City of Portland, Maine - Building or Use Permit Application

Permit No: 03-1328	Issue Date: OCT 28 2003	CBL: 022 J008001
-----------------------	-----------------------------------	---------------------

Proposed Project Description: Interior gut renovation & new structural supports of 1st & 2nd floors, walls, kitchens & Bathrooms	FIRE DEPT: <input type="checkbox"/> Approved <input type="checkbox"/> Denied INSPECTION: Use Group: R3 Type: 5B Signature: <i>JMB 10/28/03</i> Signature: <i>JMB 10/28/03</i>
---	--

1st Floor

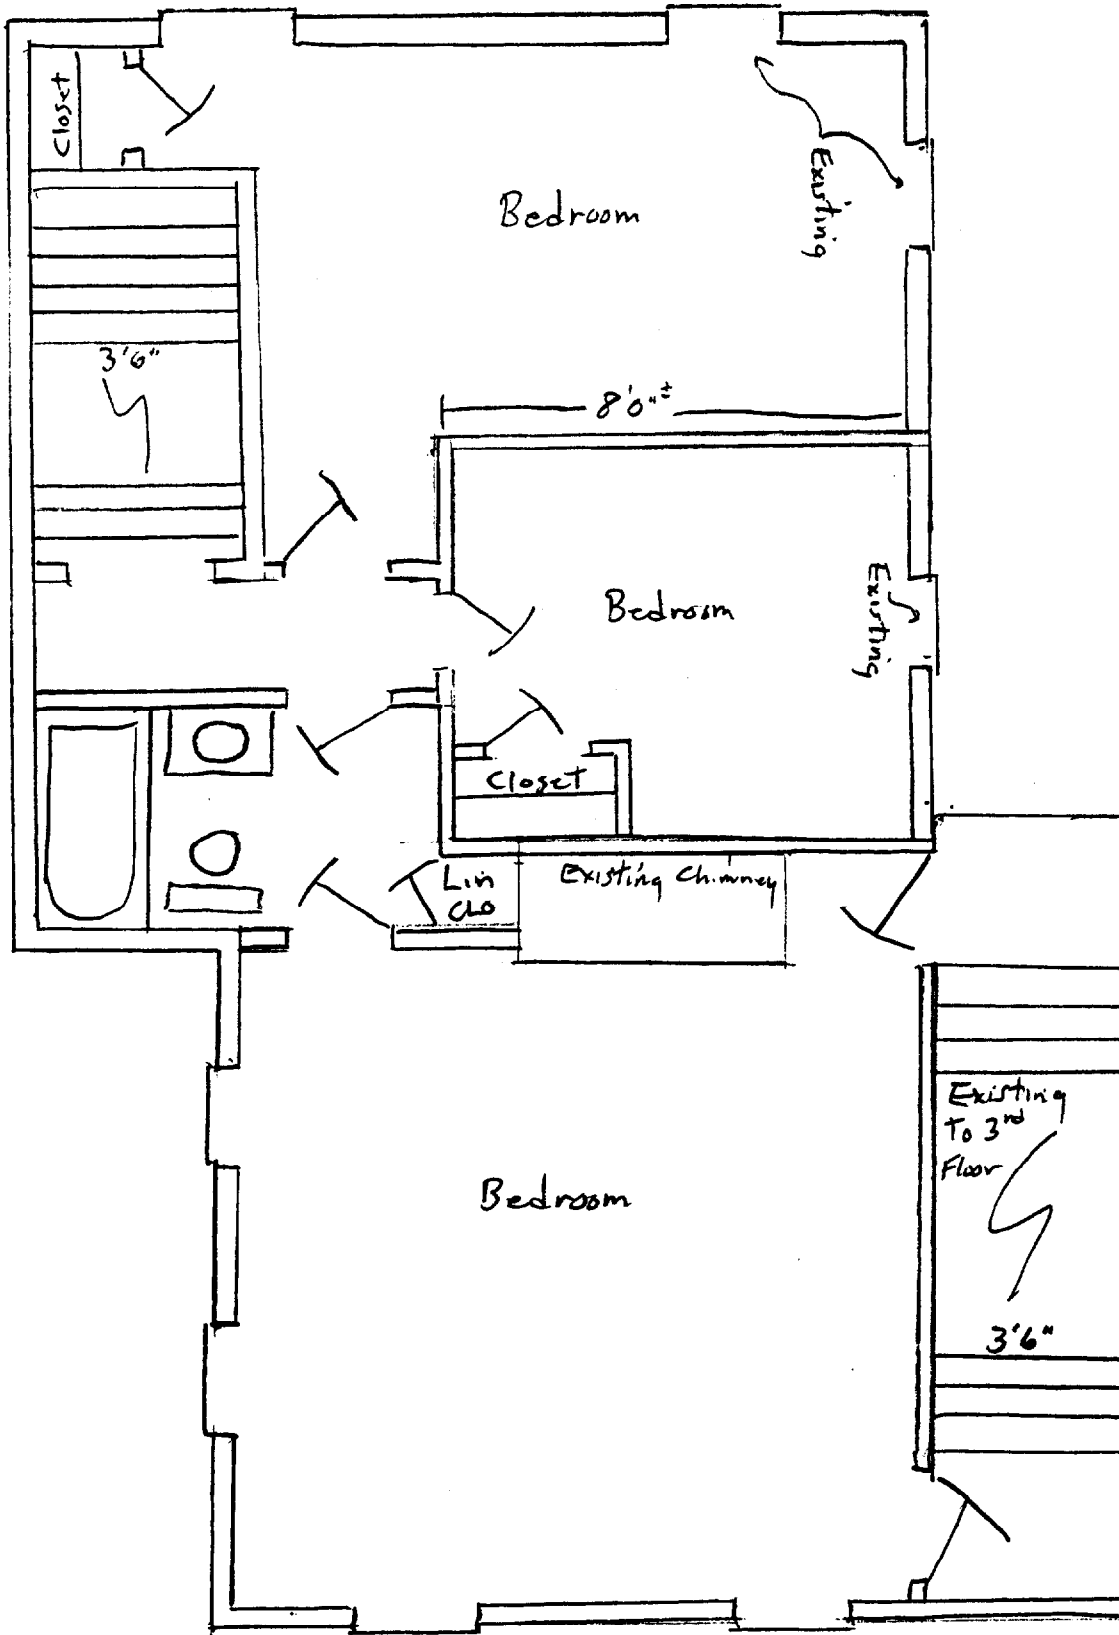
handrail
one side
34-38"
-return
ENDS

OK

?
2-12" Micro-lans To support
Existing 2nd floor Joists
